2699 KINGSWAY (COMPLETE APPLICATION)  
DE415099 - ZONE CD-1 (Pending)

**DEVELOPMENT PERMIT STAFF COMMITTEE RECOMMENDATION: APPROVE**

THAT the Board APPROVE Development Application No. DE415099 submitted, the plans and information forming a part thereof, thereby permitting a new mixed-use development comprised of two buildings (12 storey and 4 storey) separated by a public plaza, both with commercial uses at grade, separate underground parking (5 and 3 levels) and residential units above for a total of 130 dwelling units with parking accessed from the lane, subject to Council's enactment of the CD-1 By-Law and approval of the form of development and the following conditions:

**A-2.3**

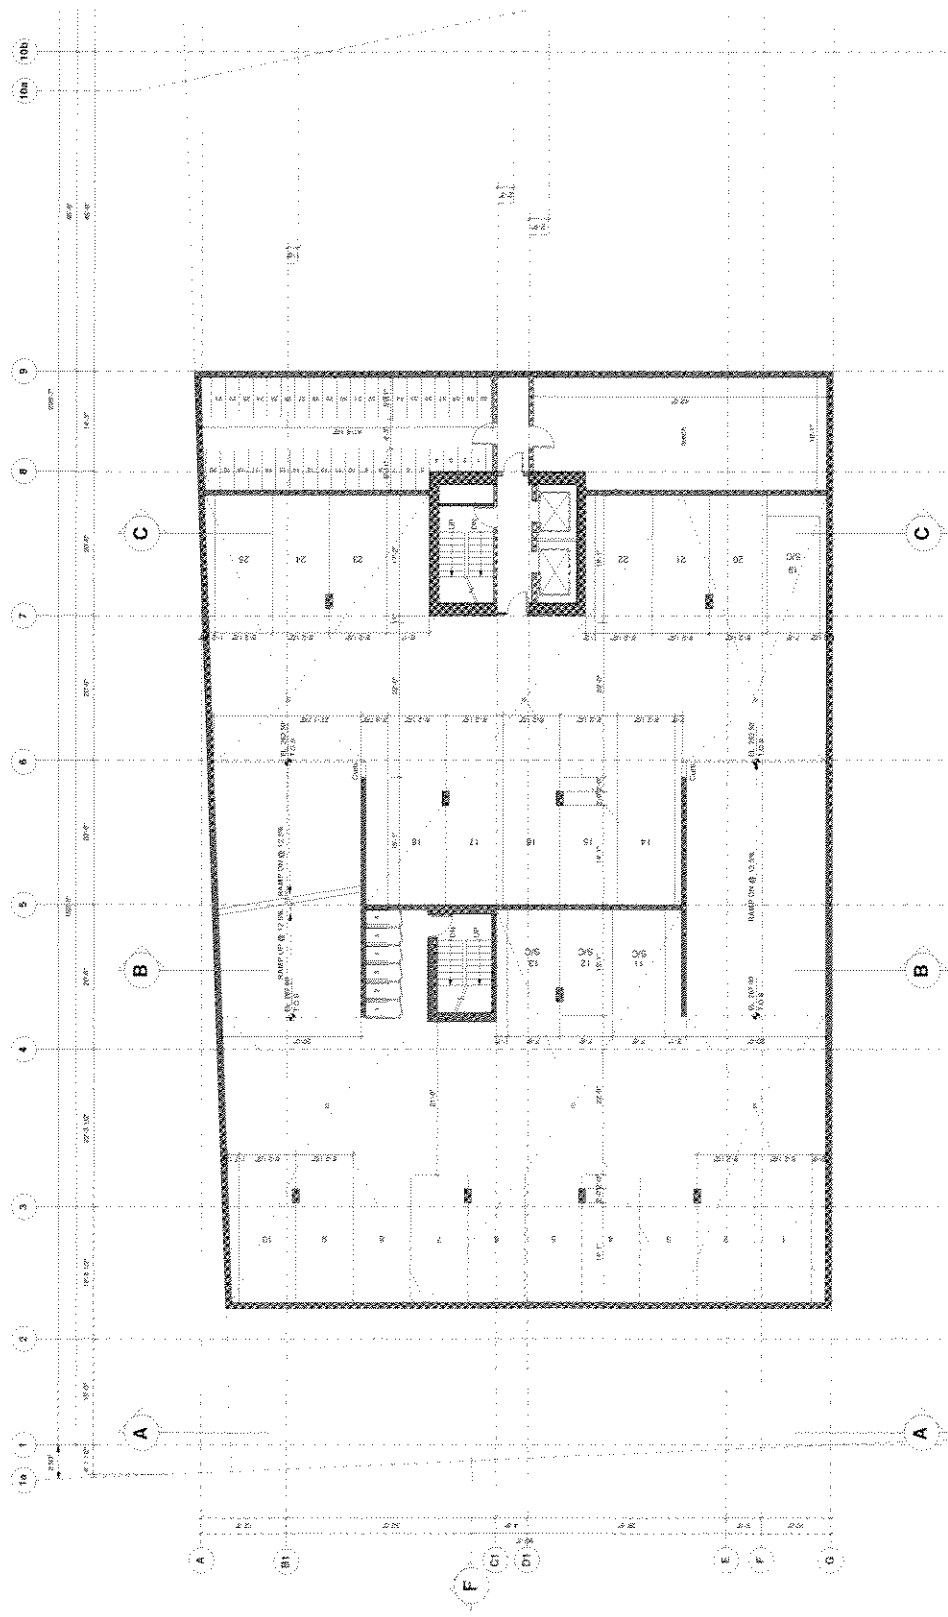
24. provide bicycle wheel ramps for the stairs located at gridline C1/8 on drawing A-2.3;

**A-2.5**

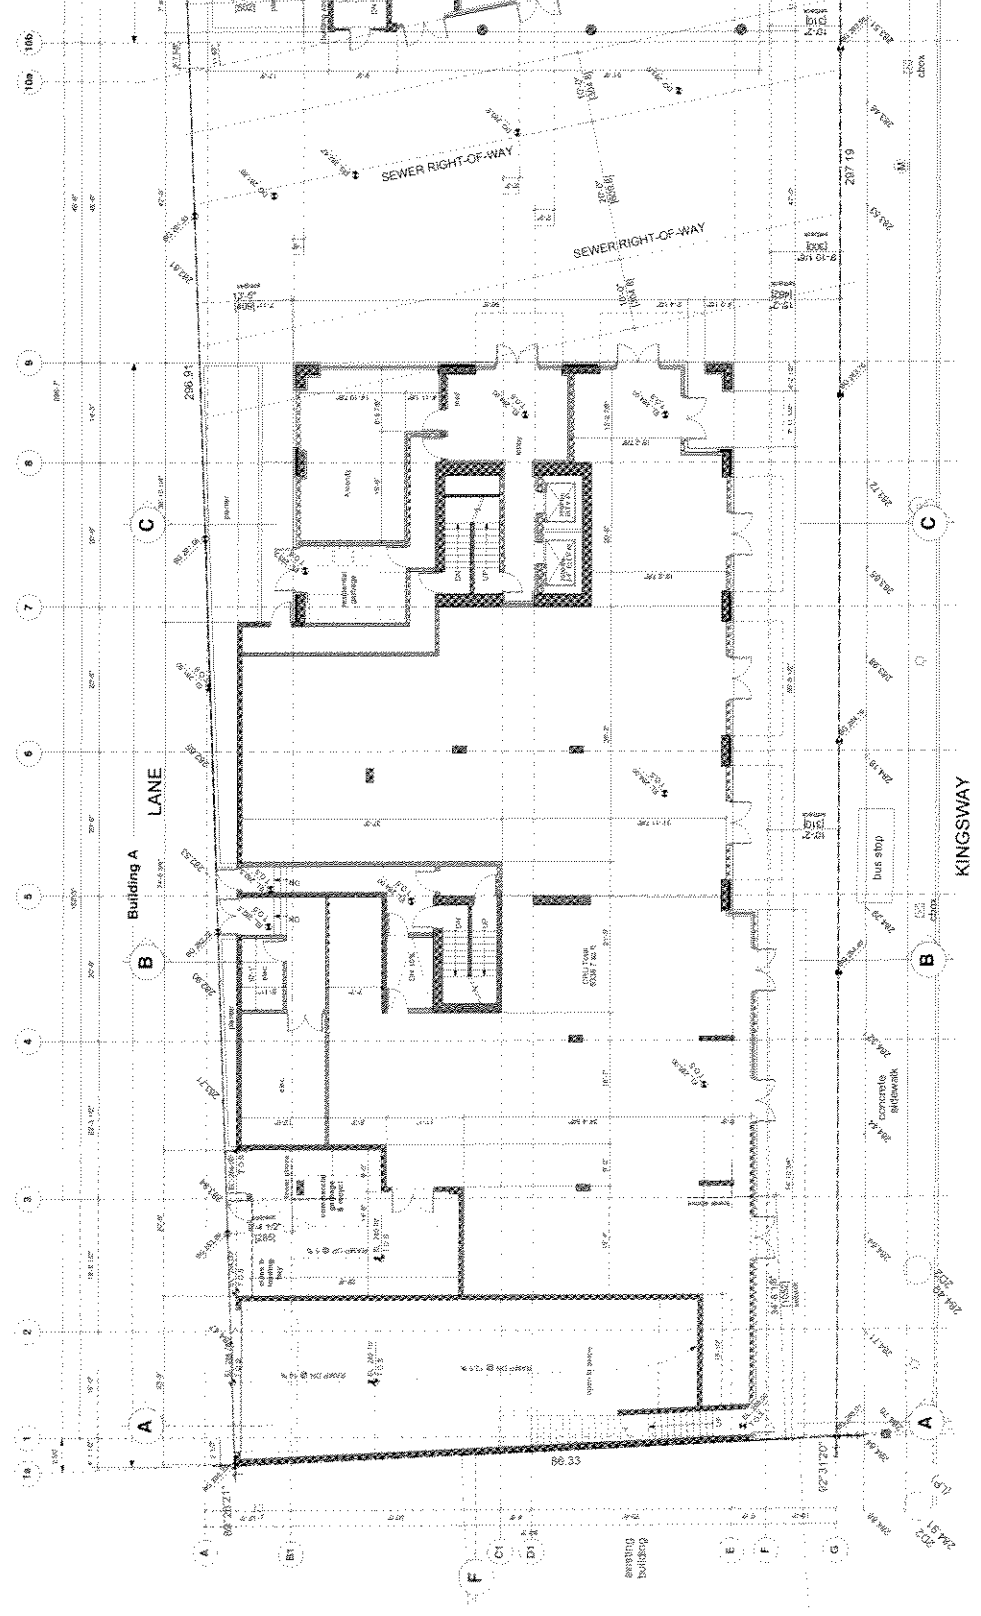
20. redesign the Class B loading bay shown on drawing A-2.5 to include the following:
- remove the corner protruding out into the main ramp by angling the westerly wall to align with gridline 2; and
- relocate the loading doors to provide a minimum of 28 ft. depth when the doors are closed;

DRAWING NO: A-2.14

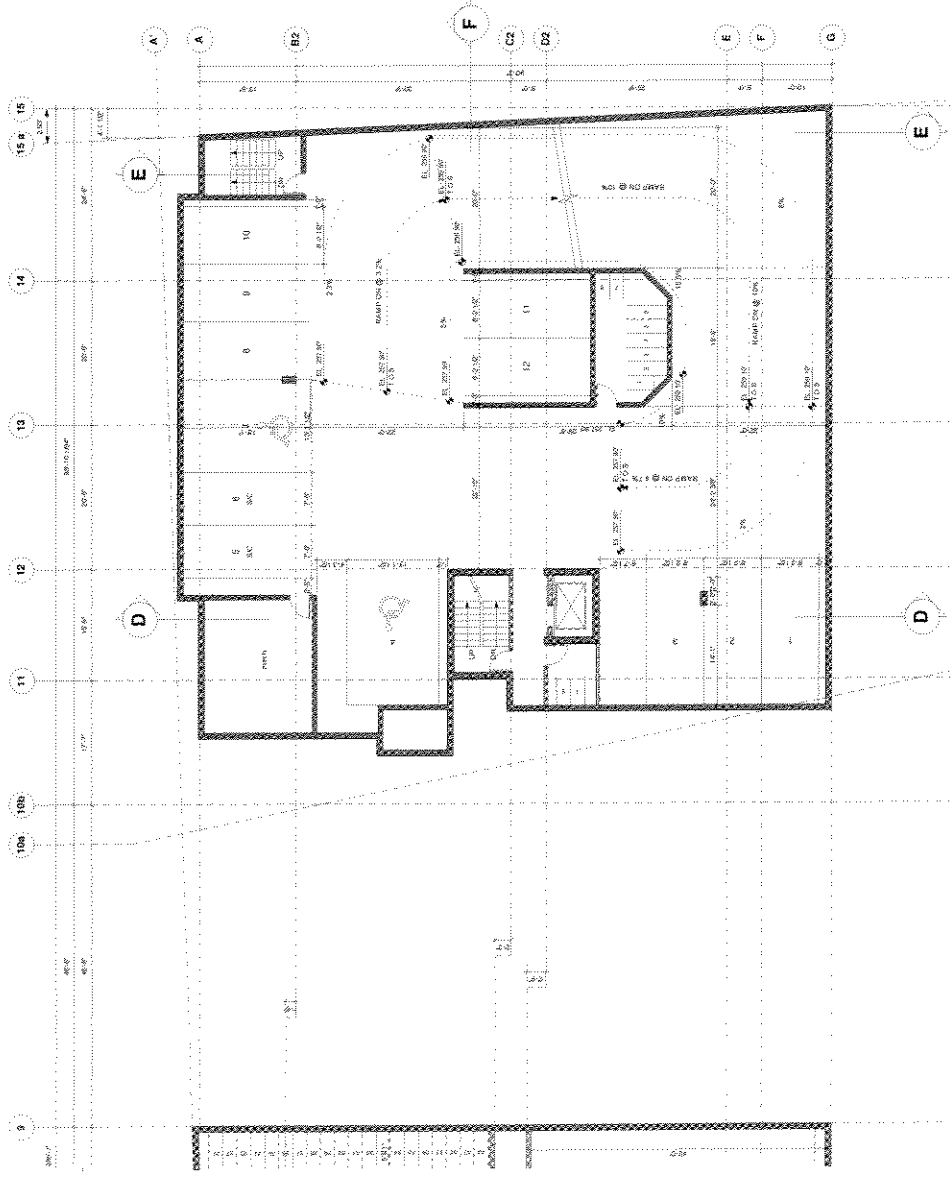
30. provision of a view portal in the bicycle room along gridline 13 to see oncoming traffic in the drive aisle on drawing A-2.14;

Section A-A

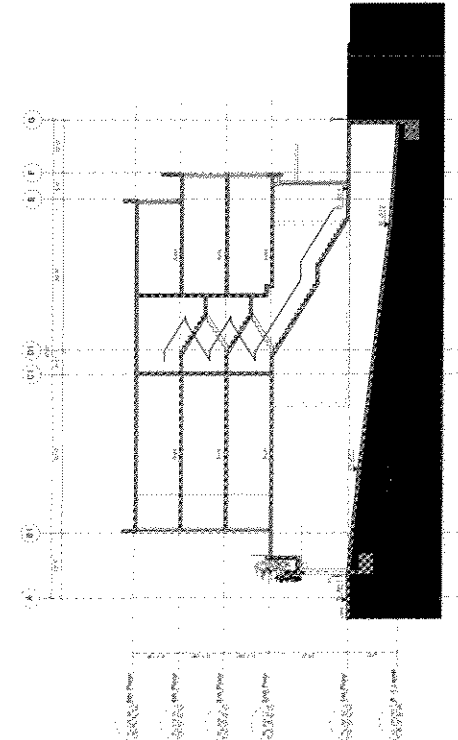
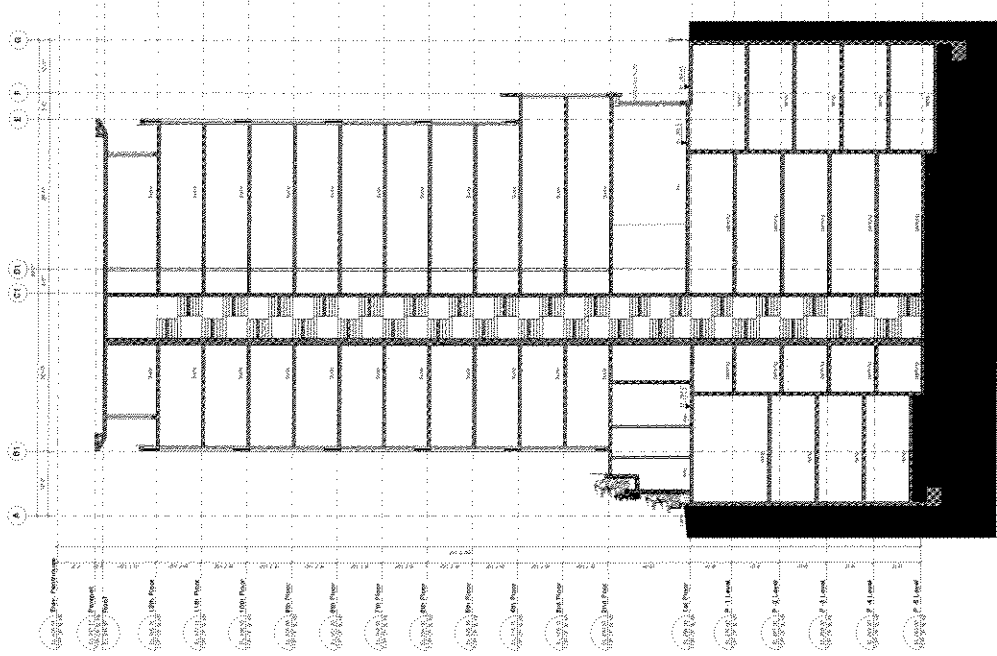
Note to Applicant: The vertical clearance at gridline E on Section A-A for Building A (drawing A-4.1) measures 7 ft.

Section D-D

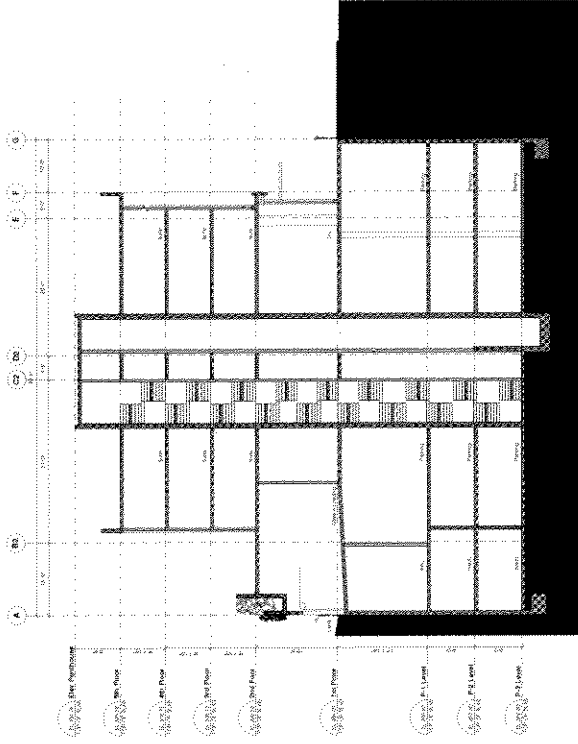
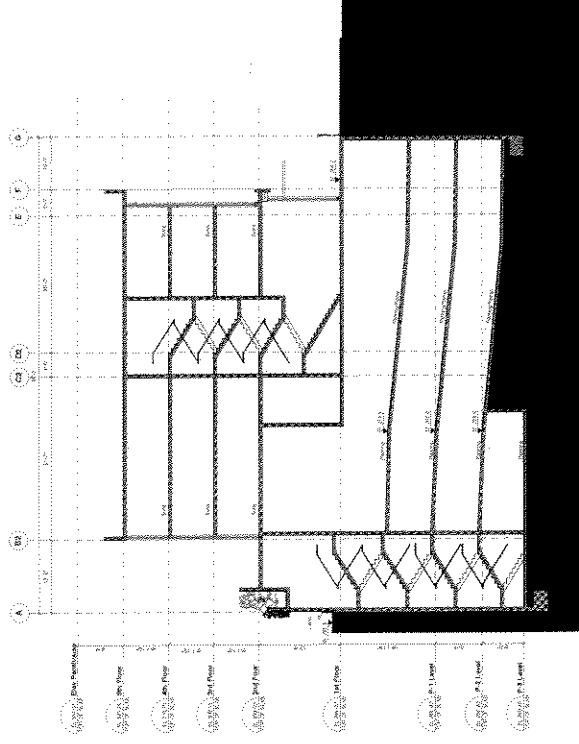
A.1.13 design development provide safe access for planter maintenance and greater amenity to the 2<sup>nd</sup> floor patios by raising the planters currently located midway up the lane edge building façade (see architectural section B-B, D-D and E-E) to the level of the 2nd floor patios;

**Note to applicant:** These planters should include some trailing plants capable of draping over the planter edge and down the exposed face of the building.

Section B-B

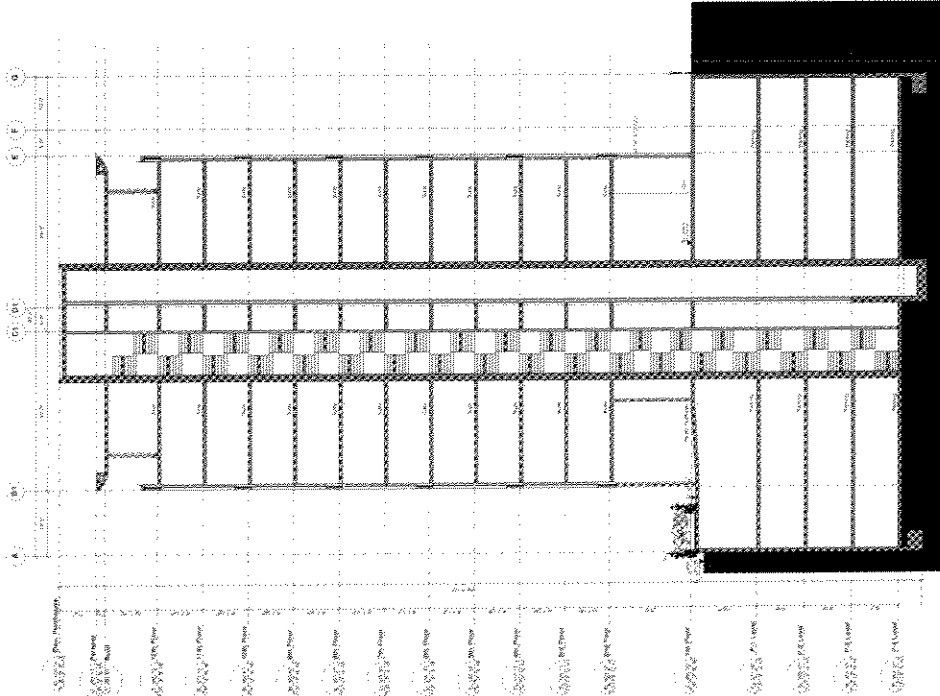
Note to Applicant: This can be achieved by raising the planters currently located mid-way up the north façade (see Sections B-B and C-C on drawing A-4.1) to the level of the 2nd floor patios. These planters should include some trailing plants capable of draping over the planter edge and down the exposed face of the building.
